**INSPECTION – NLG / MLG – PALNUTS**

To replace the Nose Landing Gear attachment fasteners, installing castellated nuts and locking pins, replacing the friction locking nuts previously installed.

To inspect the Main Landing Gear attachment bolts and installing Palnuts as required.

Issue 4 adds alternatives to the bolt P/N NAS6606D63 and NAS6606D68.

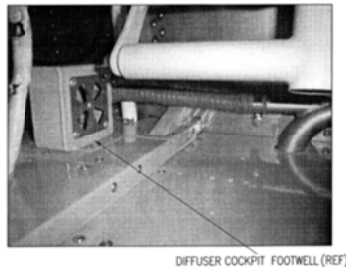
- 1) Inspect the lower attachment bolts on the nose landing gear.
- 2) Check for loose bolts and gaps between the clamp and firewall.
- 3) If the bolts or the clamp look or feel loose, you must proceed to Part B prior to operating the aircraft.
- 4) Upon first inspection, add torque stripe at bolt head checking daily for relative movement.

- 5) Check daily if there is any misalignment on the stripe added in Step 4. If there is, you must proceed to Part B prior to operating the aircraft.

**FIGURE 3 NOSE LANDING GEAR – HARDWARE REPLACEMENT**

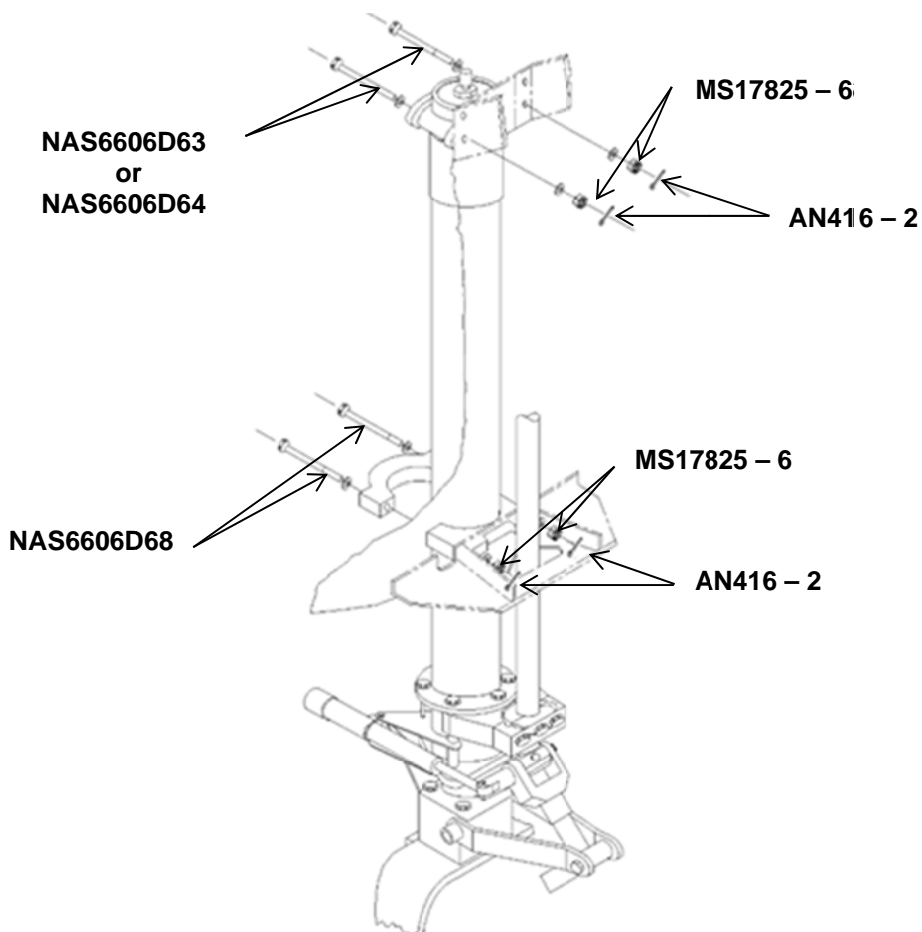
- 5) Remove the Upper Engine Cowl to get access to the upper attachment area of the Nose Landing Gear (Ref. 750XL MM, Chapter 71).
- 6) Replace existing hardware with the following:
  - Bolts – NAS6606D63 or alternate parts (refer to Section 6. Material List)
  - Nuts – MS17825 – 6 [Torque to 160-260 lb.in]
  - Spring Pin / Split Pin – AN416-2 or MS24665-283

- 7) In the Lower Engine Cowl area, access the lower attachment bolts of the Nose landing gear.
- 8) Replace existing hardware with the following:
  - Bolts – NAS6606D68 or alternate parts (refer to Section 6. Material List)
  - Nuts – MS17825 – 6 [Torque to 160-260 lb.in]
  - Spring Pin / Split Pin – AN416-2 or MS24665-283

**NOTE:** The Bolts P/N NAS6606D63 may be fabricated from P/N NAS6606-63 iaw PAL DWG BOL6606 (refer to the attached drawing).

**NOTE:** The Bolts P/N NAS6606D64 may be fabricated from P/N NAS6606-64 iaw PAL DWG BOL6606 (refer to the attached drawing). If using this bolt you must use an additional washer P/N AN960-616 directly behind the nut.

**NOTE:** The Bolts P/N NAS6606D68 may be fabricated from P/N NAS6606-68 iaw PAL DWG BOL6606 (refer to the attached drawing).

**FIGURE 6 MAIN LANDING GEAR (SHORT RANGE WING AND AIRCRAFT WITH MODS 0451 / 0509 / 0663) - INSPECTION**

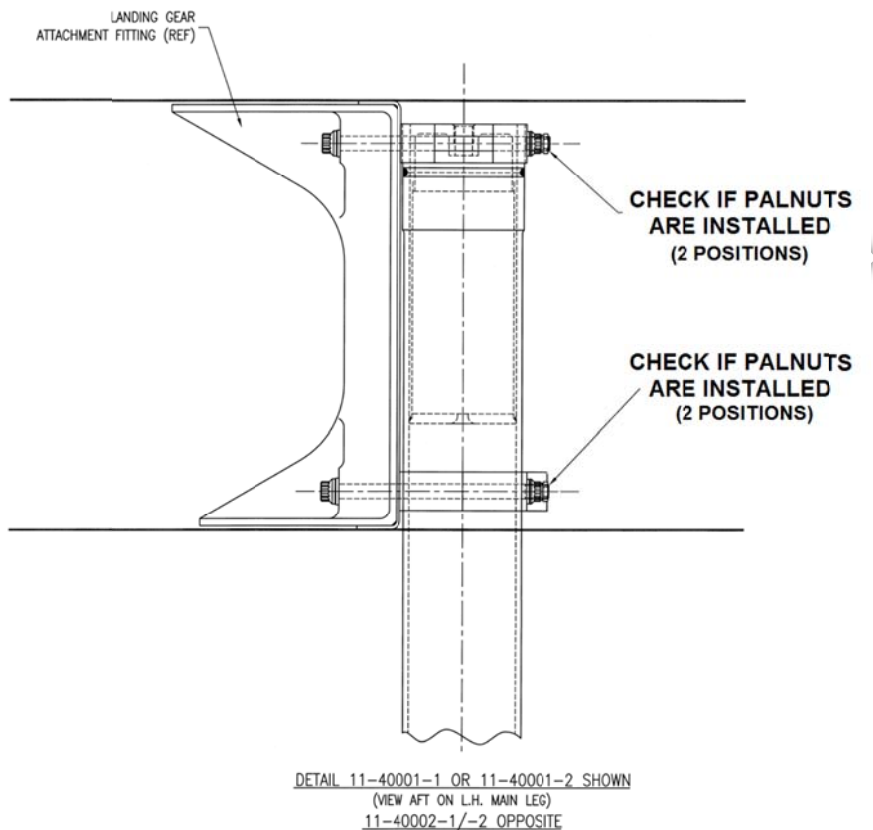
- 4) Inspect the Main Landing Gear attachment bolts (See Figure 6):
- If the Palnuts are installed in eight bolts locations (four on each MLG), no further action is required. Go to Step 8) and record compliance with this Service Bulletin Part B.
  - If the Palnuts are not installed in eight bolts locations (four on each MLG), go to Step 5).

**FIGURE 7 MAIN LANDING GEAR (SHORT RANGE WING – TORQUE CHECK AND PALNUTS INSTALLATION)**

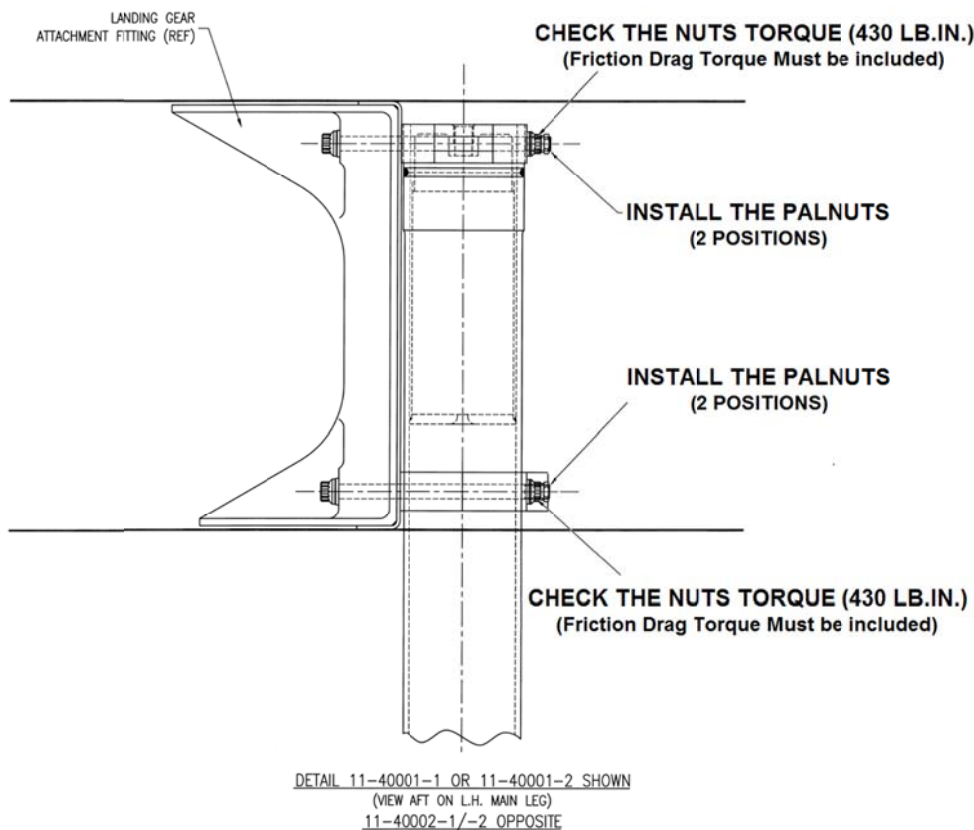
- 5) Check the torque of the Main Landing Gear upper attachment bolts (See Figures 7 and 8).

**NOTE 1:** For Short Range Wing Aircraft (3/8 bolt), the torque value should be 430 lb.in. (friction drag torque must be included). Torque the bolts again, if necessary.

- 6) Install the Palnuts P/N MS27151-19 (for Short Range Wing Aircraft) or P/N MS27151-21 (for MOD`s 0451, 0509 and 0663) to the upper attachment bolts of the Main Landing Gear.

**NOTE:** Palnuts should be tightened securely but not excessively. Finger-tight plus ¼ turn or two flats.

**FIGURE 8 MAIN LANDING GEAR (AIRCRAFT WITH MODS 0451 / 0509 / 0663) – TORQUE CHECK AND PALNUTS INSTALLATION**

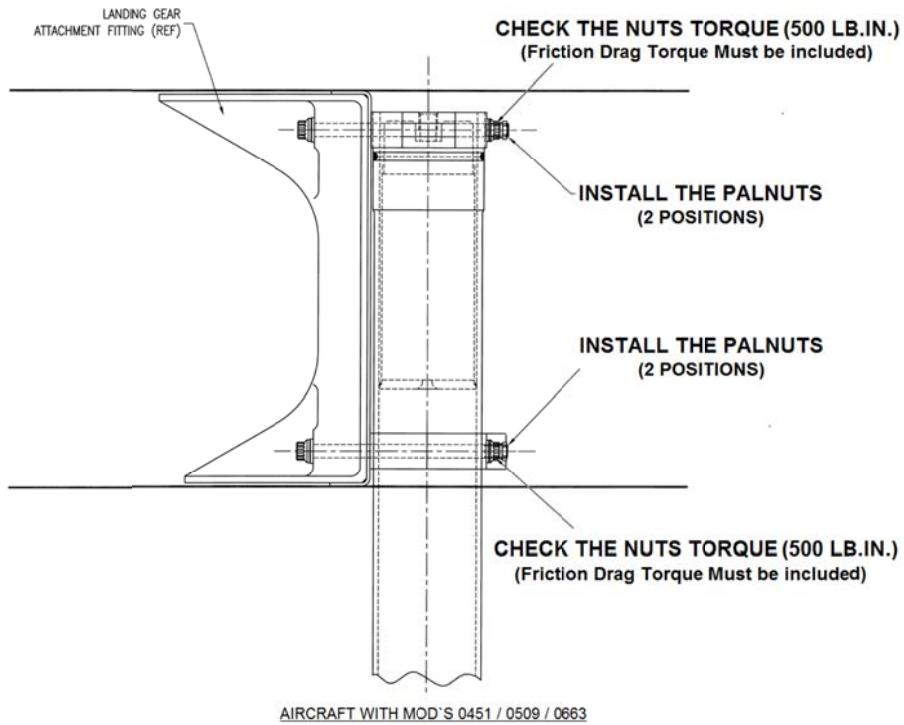
**NOTE 2:** For MODs PAC/XL/0451, 0509 and 0663 (7/16 bolt), the torque value should be 500 lb.in. (friction drag torque must be included). Torque the bolts again, if necessary.

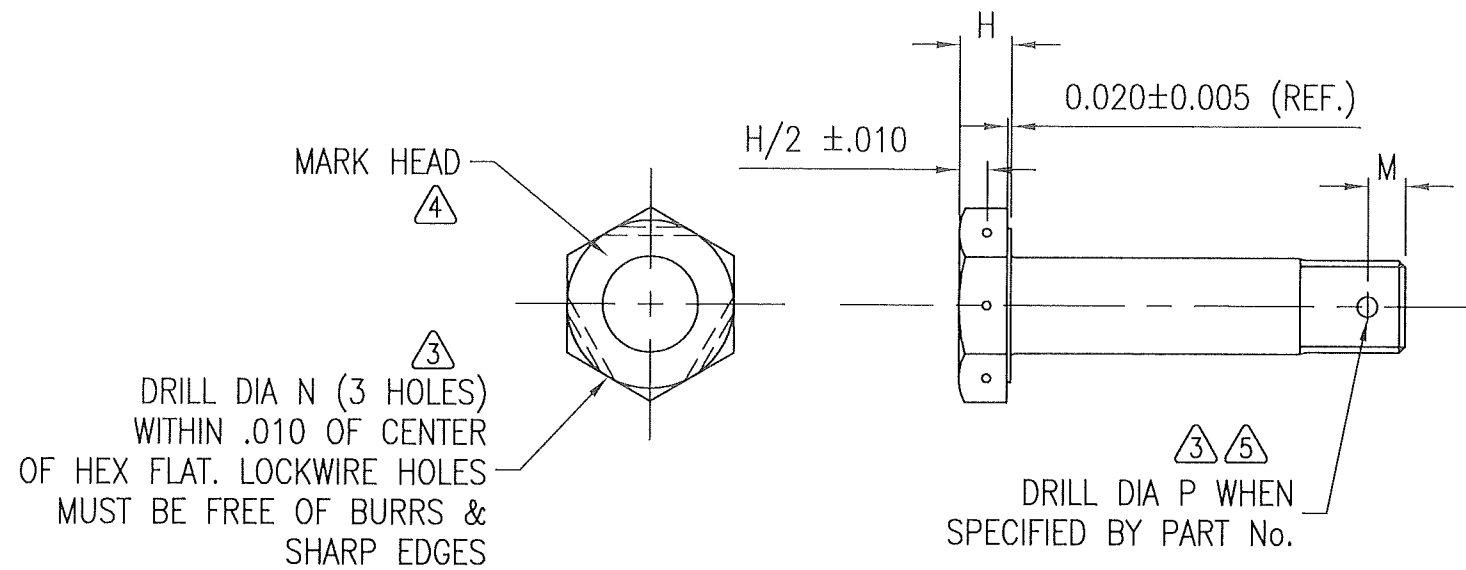
- 1. COMPONENTS ON THIS DRAWING TO BE MADE IN ACCORDANCE WITH COMPANY APPROVED MANUFACTURING STANDARDS AND PROCEDURES.
- 2. MANUFACTURE FROM: NAS6603-xx THRU NAS6620-XX OR NAS6603-xxX THRU NAS6620-xxX.

- 7. MODIFIED BOLTS TO BE PROTECTED BY APPLICATION OF CRC 3-36 CORROSION INHIBITING COMPOUND OR EQUIVALENT CONFORMING TO MIL-C-81309E, APPLIED TO THE HEADS AND DRILLED HOLES.

3 ALL DIMENSIONS TO CONFORM TO THE EQUIVALENT NAS SPECIFICATIONS. PROVIDED DIMENSIONS REF. ONLY

4 VIBRO ETCH OUT MANUFACTURER'S MARK AND MARK WITH PAL MARK WHERE INDICATED.

5 COTTER PIN HOLE CENTRELINE: WITHIN .010 AND NORMAL WITHIN 2" OF BOLT CENTRELINE.

6 "BOL" REPLACES "NAS" FOR THE DRILLED BOLT PART NUMBER. ADD "D" AFTER BASIC PART No. FOR DRILLED SHANK BOLTS. ADD "H" AFTER BASIC PART No. FOR DRILLED HEAD BOLTS.
